LIGO Laboratory / LIGO Scientific Collaboration

E1100867-v15

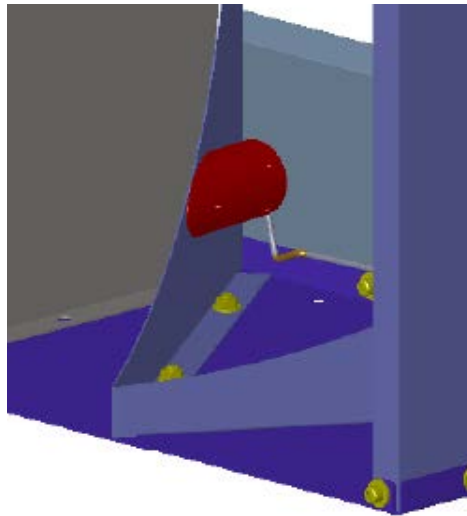
7. Lay Assembly down
8. Attach “SLC Arm Cavity Baffle Center Skin” D1000976 and “Arm Cavity Baffle Center, Mirror Skin” D1101796 to “SLC Arm Cavity Baffle Bottom Skin” D1000975 and “Brace, Lifting, Arm Cavity Baffle” D1101427. Refer to D1200657 or D1200314 assembly drawing Detail B on Sheet 2 for clarification.
 - a. Install hardware 6 places
 - b. Round Holes (screw, SSTL, Brace, washer, nut)
 - i. FA-2412-NA, Flat Head Screw #10-24 X 3/4”L, SSTL - oxidized, Qty 6
 - ii. 98019A330, Flat #10 Washer, SSTL, Qty 6
 - iii. N-1024-A, Hex Nut #10-24, SSTL - Silver Plated, Qty 6
